National Transportation Safety Board

Safety Recommendation

Date: December 3, 1998

In reply refer to: A-98-125 and -126

Figure 1. Cross section of CF6-50 engine and expanded view of LPT module

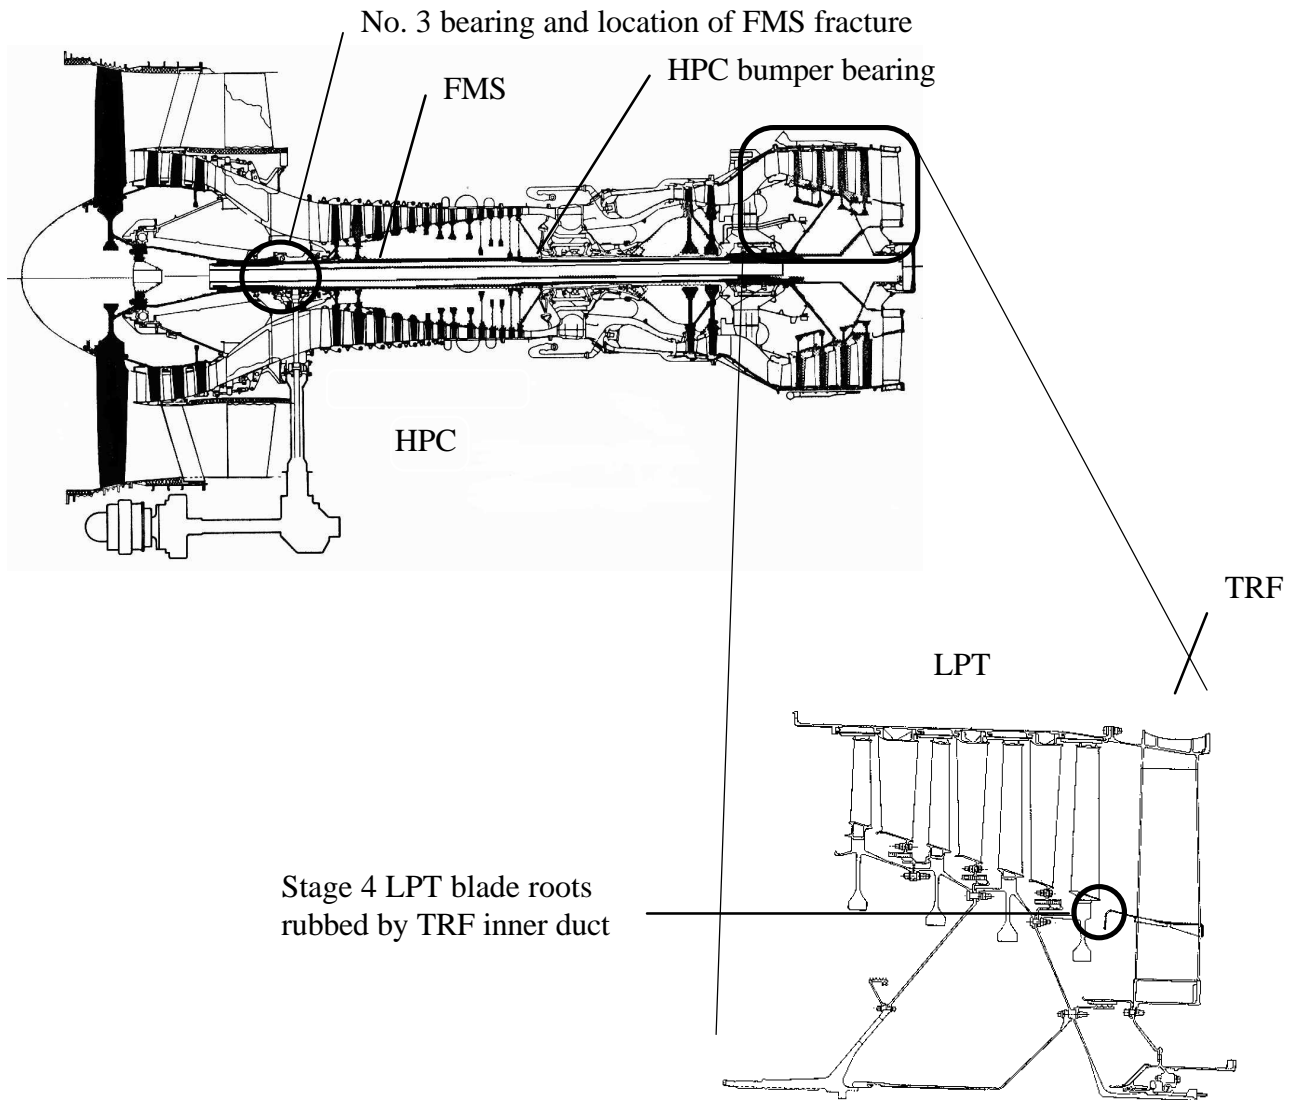
The examination of the No. 2 engine revealed that most of the LPT module was missing (see figure 1). The airplane had punctures to its left wing leading edge slats and to a landing gear door. In addition, the No. 1 engine had hard body impact damage⁴ to 18 of the 38 fan blades, and the fan cowl had impact damage from the debris ejected from the No. 2 engine.

The disassembly of the PIA engine showed that the center section of the FMS had become wedged into the high pressure compressor (HPC) bumper bearings. The design of the CF6-50 engine's FMS is such that the OD of the forward half of the shaft is greater than the inner diameter of the bumper bearing on the inside of the HPC rear hub. On the PIA engine, when the FMS fractured at its forward end, the rear section moved aft, and the larger diameter section of the shaft became wedged into the bumper bearing, limiting the rearward movement of the LPT

GE reported that a dimensional inspection of the LPT disks showed that the disks had "grown," indicating that the LPT rotor had accelerated to 140 percent rpm.¹³ The Safety Board is concerned about the LPT rotor overspeeds and uncontained LPT damage that occur even when the flightcrew promptly retards the engine power, as was done by the Continental Airlines flightcrew. The Safety Board is further concerned about the extent of resultant damage when an FMS fracture occurs and the flightcrew cannot immediately reduce power on the affected engine, such as on the PIA flight. The rubs on the rear faces of the stage 4 LPT blade roots and the wedging of the FMS into the HPC bumper bearing, which were noted on the PIA and Continental Airlines engines, indicate that the meshing action of the CF6-50 engine's LPT rotor is being impeded. The turbine disk growth that was noted on the Continental Airlines engine shows that the limited meshing action allowed the overspeed of the LPT. Therefore, the Safety Board believes that the Federal Aviation Administration (FAA) should require GE to modify the CF6-50 engine to eliminate the impediments to the aft translation of the LPT rotor that limits the amount of meshing that occurs in the event of an FMS fracture.

Require General Electric Aircraft Engines to modify the CF6-50 engine to eliminate the impediments to the aft translation of the low pressure turbine rotor that limits the amount of meshing that occurs in the event of a fan midshaft fracture. (A-98-125)

Figure 2. Cross section of CF6-80C2 engine and expanded view of LPT module

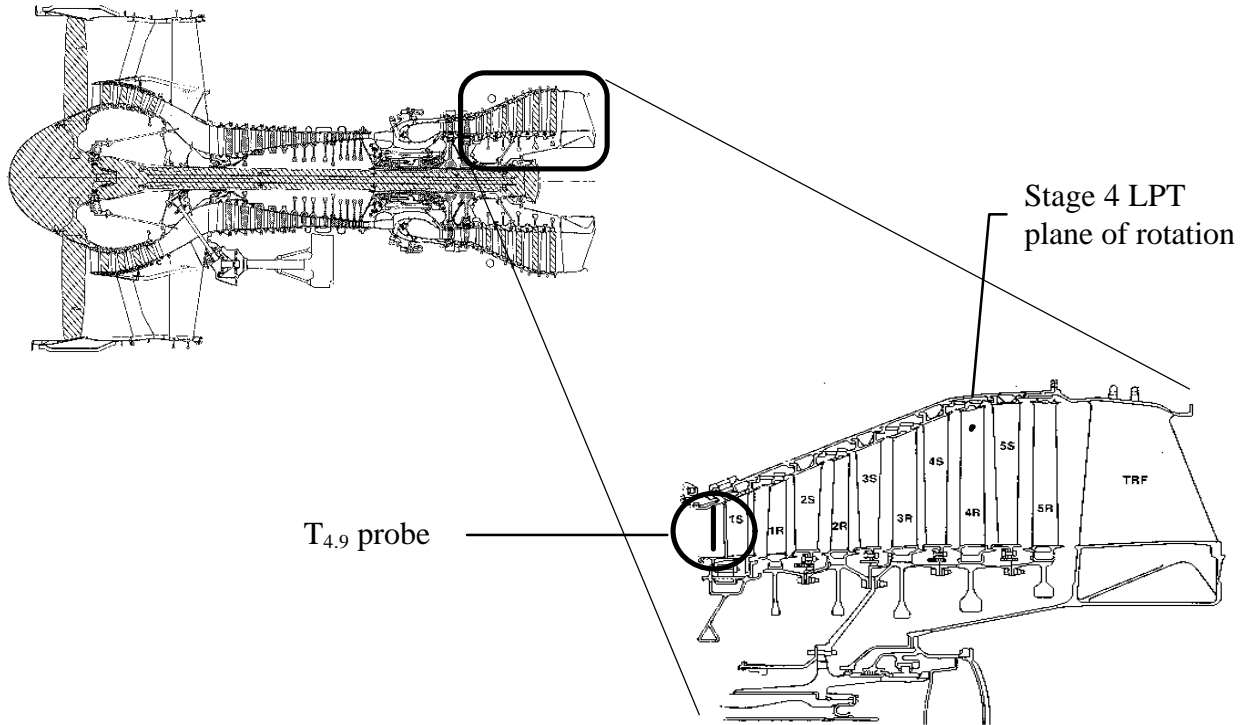
The engine was disassembled and examined under the direction of the Safety Board at Motoren-und Turbinen-Union (MTU), Hannover, Germany.¹⁵ The disassembly revealed that the tip of one interturbine temperature ($T_{4.9}$)¹⁶ probe had broken off and impacted one stage 1 LPT blade, causing a fatigue fracture of the airfoil near the blade tip shroud (see figure 2). All of the stage 2, 3, 4, and 5 LPT blades were found in their respective disks; however, all were fractured transversely across the airfoils at various lengths above the blade root platforms. The disassembly also revealed that the LPT case had a 17-inch by 2-inch wide hole in the stage 4 LPT plane of rotation. The damage to the LPT rotor was progressively worse along the gaspath, suggesting that the stage 1 LPT blade tip separated first, that all of the blades in the following stages were then fractured, and that the mass of material became larger as it progressed through the rotor, subsequently resulting in a case rupture in the stage 4 area.

The Safety Board is aware of a similar event that occurred on September 5, 1997, when a Federal Express (FedEx) McDonnell Douglas MD-11 airplane, equipped with GE CF6-80C2 engines, had an uncontained LPT failure in the plane of the stage 4 LPT rotor. The disassembly of the FedEx engine showed that a stage 1 LPT airseal segment had broken loose from the LPT case and passed through the gaspath causing the breakage of the downstream turbine blades. As in the American Airlines LPT, the damage in the FedEx LPT rotor was more extensive downstream along the gaspath. The evidence shows that both the American Airlines and FedEx LPT cases withstood the initial containment challenge of the separation of an LPT blade; however, neither case could withstand the loads imparted by the resultant mass of broken LPT airfoils. This suggests that the design containment capability of the LPT case is inadequate.

turbine containment are further addressed in 14 CFR 33.75, which notes in part that “any probable single or multiple failure...will not cause an engine to...burst (release hazardous fragments through the engine case).” Because the uncontained LPT failures in the CF6-50 and -80C2 engines were attributed to a number of different causes, the LPT containment capability of these engines must be improved to comply with 14 CFR 33.19 and 33.75.

Require General Electric Aircraft Engines to improve the ability of the CF6-50 and the CF6-80 series engines to prevent fractured low pressure turbine blades from being liberated through the engine cowling. (A-98-126)
